# UNITED STATES PATENT AND TRADEMARK OFFICE

APPLICATION N	₹O.	FILING DATE	FIRST NAMED INVENTOR	ATTORNEY DOCKET NO.	CONFIRMATION NO.		
10/807,350		03/24/2004	Frank Rosemann	A-10040	5378		
181	7590	01/31/2005		EXAM	EXAMINER		
	& STOCK	BRIDGE PC	SCHULTERBRA	SCHULTERBRANDT, KOFI A			
SUITE 5		KI V L	ART UNIT	PAPER NUMBER			
MCLEA	N, VA 221	102-3833	3632				
			DATE MAILED: 01/31/2005

#### **DETAILED ACTION**

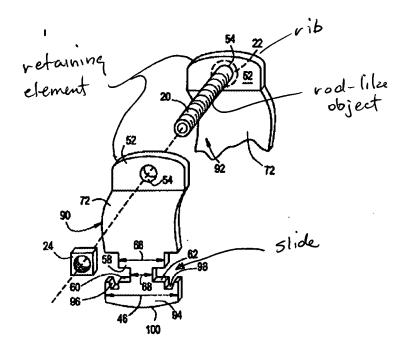
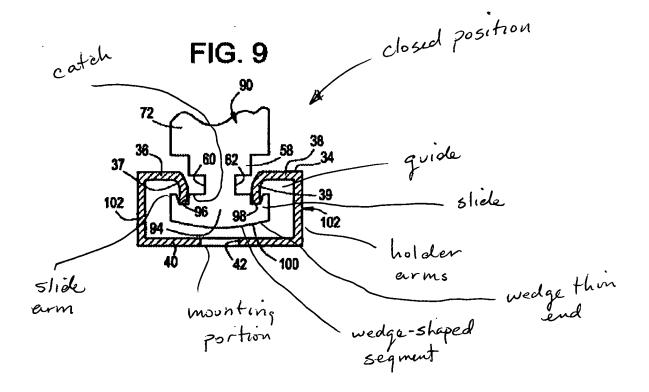
Claims 1,3-5, 7-11, 13-15 are rejected under 35 U.S.C. 102(b) as being anticipated by Andronica (5,799,907). Andronica teaches each feature of the claimed invention as shown and discussed below. Andronica teaches a mounting portion (42) (See col. 3, Ins. 66 and 67), holding arms (38, 39 and 102; Figure 8), a retaining element ((70); Figure 3), and open position ((102) and (70) not engaged yet), a closed position ((102) and (70) engaged), a guide (between 36, 38, 40 and 102; Figure 9), a wedge-shaped segment (94; Figure 9), a slide ((98); Figure 7), a rib ((52); Figure 7), a rod-like object ((20); Figure 7), a prism shaped guide groove (between (38, 39 and 102); Figure

9), a guide segment/arms opposed to the holder arms ((96); Figure 7), catch ((62);

Figure 7), and retaining elements ((39); Figure 9).

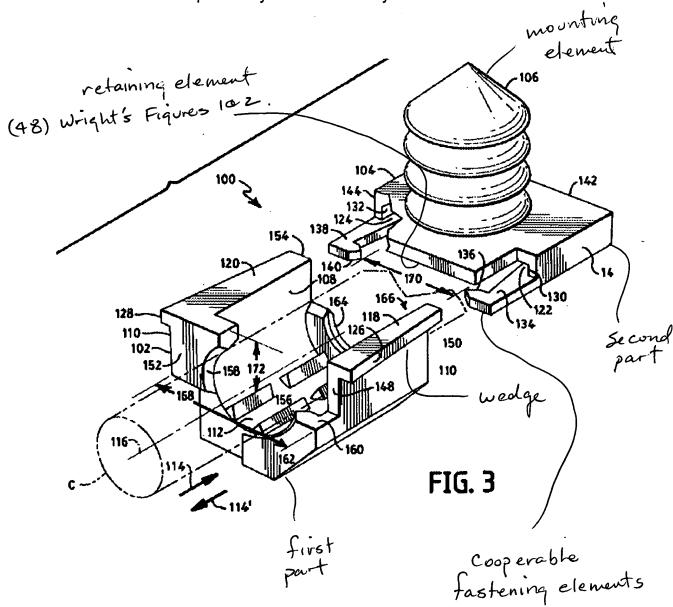
Claim16-18 and 20 are rejected under 35 U.S.C. 103(a) as being unpatentable over Wright (5,803,414). Wright (Figure 3) teaches, substantially, each feature of the claimed invention as shown and discussed below. Wright (Figure 3) does not teach a protuberance (48) as taught in Wright (Figures 1 and 2) that would move longitudinally into the trough or a mounting element below the trough. However, it would have been obvious to one of ordinary skill in the art at the time of invention to have modified

(Figure 3) to have a protuberance as taught by (Figures 1 and 2) in order to better stabilize the cable within the support. Furthermore, it would have been obvious to one of ordinary skill in the art at the time of invention to have modified Wright's Figure 3 to have its mounting element (106) below its trough as taught by Figure 1 as both locations would function equivalently and satisfactorily.
